City of Houston

Planning and Development Department, Development Services

Houston Planning Commission

DEVELOPMENT PLAT VARIANCE

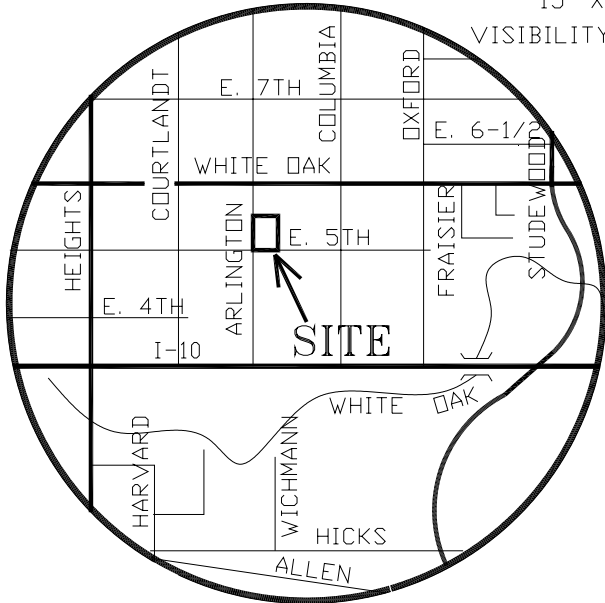
The justification for granting the variance is not solely based on an economic hardship; rather it is based on existing conditions within the site and surrounding area, as well as the current right-of-way width of Arlington Street.

DEVELOPMENT PLAT VARIANCE

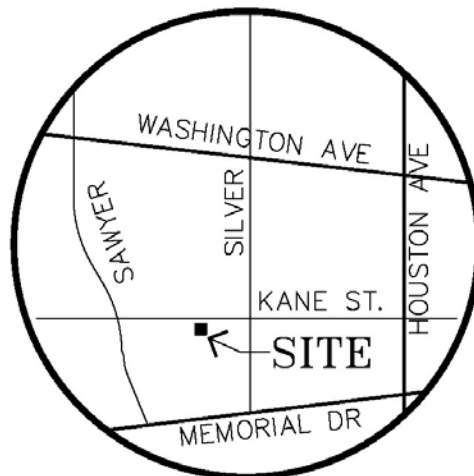
Staff finds that the granting of the variance will not be injurious to the public health, safety or welfare.

- (5) **Economic hardship is not the sole justification of the variance.**

Historic conditions are the primary justification for granting this request.
